RE: REPLACEMENT OF STURROCK DRY DOCK (SDD) INNER CAISSON GATE AT THE PORT OF CAPE TOWN FOR A PERIOD OF 24 MONTHS
TENDER NO: TNPA/2023/07/0011/34733/RFP

We have been through the tender documents and have the following queries for you.

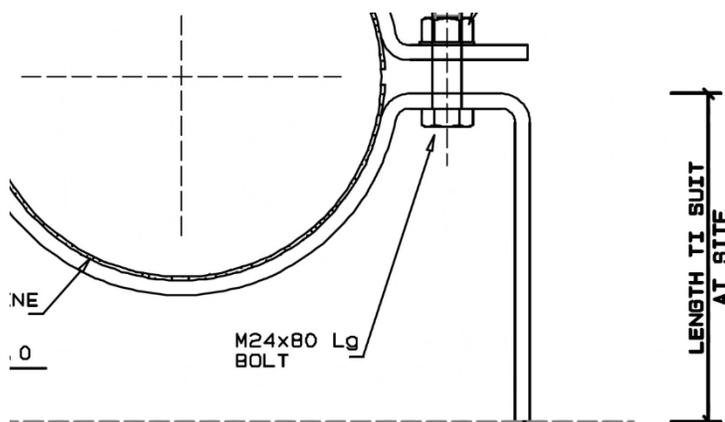
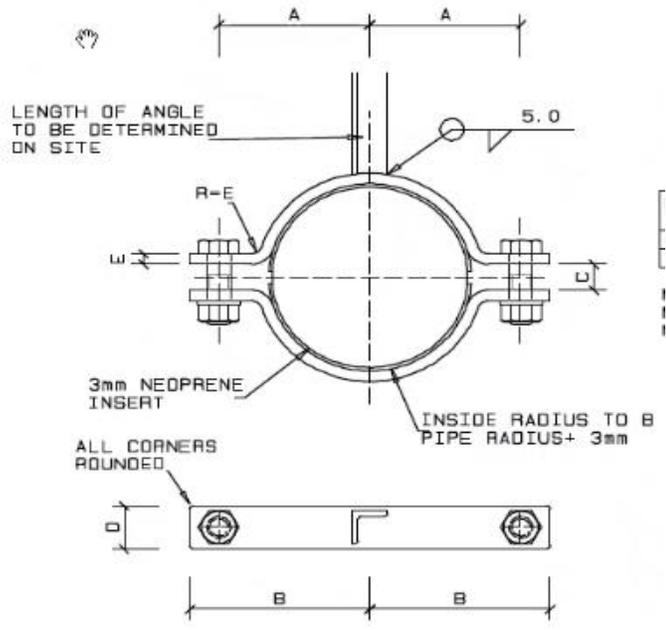
1. As per the scope of work “Section S2 Caisson Gate Mechanical and Structural Fittings” Refer to drawing 507343-0000-SS-DRG-109, The below two screenshots state “Pipe Supports and length to be determined onsite and Length of angle to be determined onsite ” There is no mentioned in the BOQ on the quantity for structural material needed for the pipe supports. Kindly provide clarity on this item or provide a new bill items with quantities so that this can be priced correctly.

- TNPA Response:** See extract below and use it to list all auxiliary items materials referring to the drawings, taking into the supplied drawing. The quantities of the pipe supports can be determined from the drawing below and applicable SANS code. The length of the angle iron of the pipe supports can be assumed to be a maximum of 0.5m per support which will be re-measurable during construction.

NOM PIPE SIZE	PIPE O. D.	A	B	C	D	E	BOLT SIZE	ANGLE SIZE
80	88.9	80	100	16	30	5	M12x45	25x25x5
150	168.3	130	155	24	40	10	M20x70	30x30x5

MAXIMUM DISTANCE BETWEEN PIPE SUPPORTS AS FOLLOWS
 N.B. 80 DISTANCE 3.0 M
 N.B. 150 DISTANCE 4.0 M
